**TOWN OF MIDWAY
PLANNING & ZONING BOARD
MINUTES
TUESDAY, FEBRUARY 28, 2023**

**CIRCLE K STORES, INC. – ADDITIONAL CANOPY WITH DIESEL PUMPS – INTERSECTION
OF OLD HIGHWAY 52 AND HICKORY TREE ROAD - CORE COMMERCIAL OVERLAY
DISTRICT (CCOD)**

PUMP FLAGS

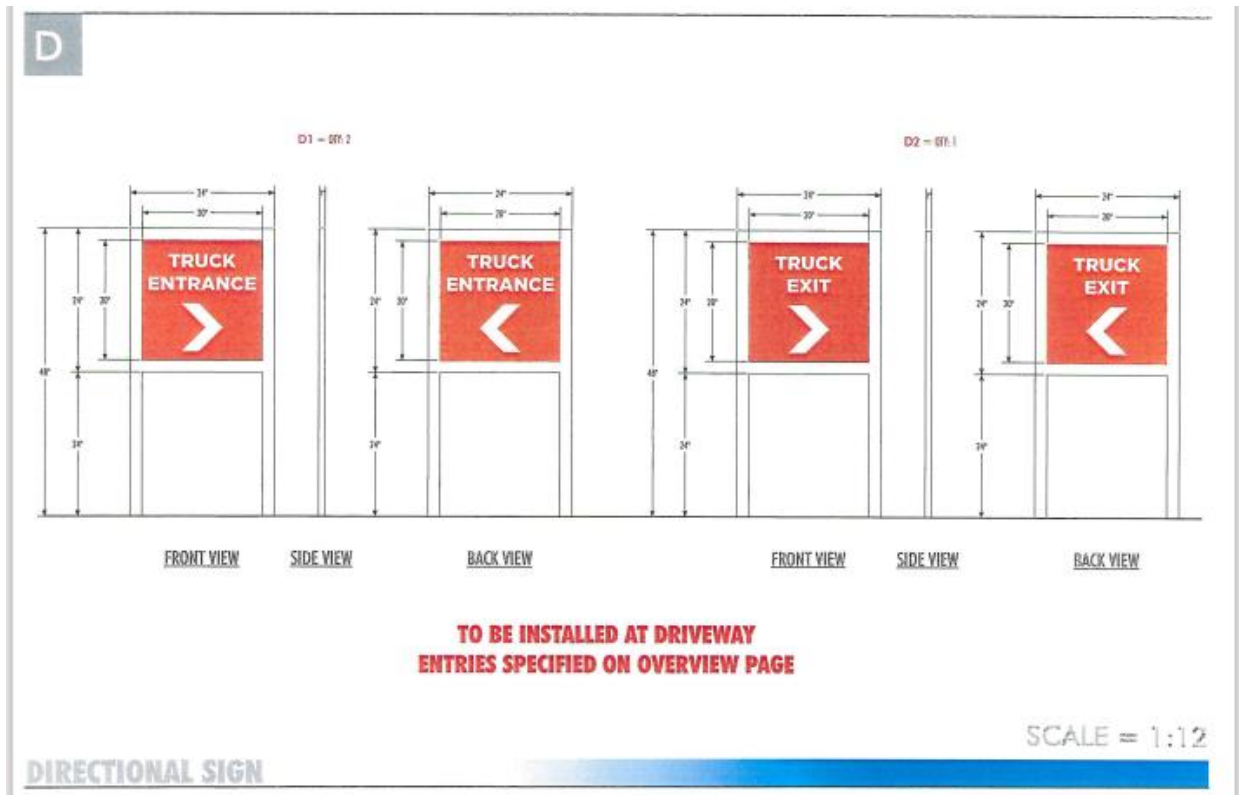
Mr. Tussey referred to Page A of the handout that shows the updated sign by the road. It adds “truck diesel” and changes some of the layout. There will also be some very minor signs added to the canopy. He added there will not be any new entrances to the gas station. The large box trucks will enter off Hickory Tree Road and exit on Old Highway 52.

Town Manager Tammy Michael pointed out there are two corrections that need to be made on the second page of the handout provided by Mr. Dooley. The municipality should be *Town of Midway*, and the contact information should be *Davidson County Planning and Zoning*.

On motion by Board member Jamie Hester, seconded by Board member James Smith, the Board voted unanimously to approve the plans for the Circle K project as submitted for the signage and canopy, contingent upon NCDOT approval of the driveways. The Board also encouraged Circle K to add some landscaping.
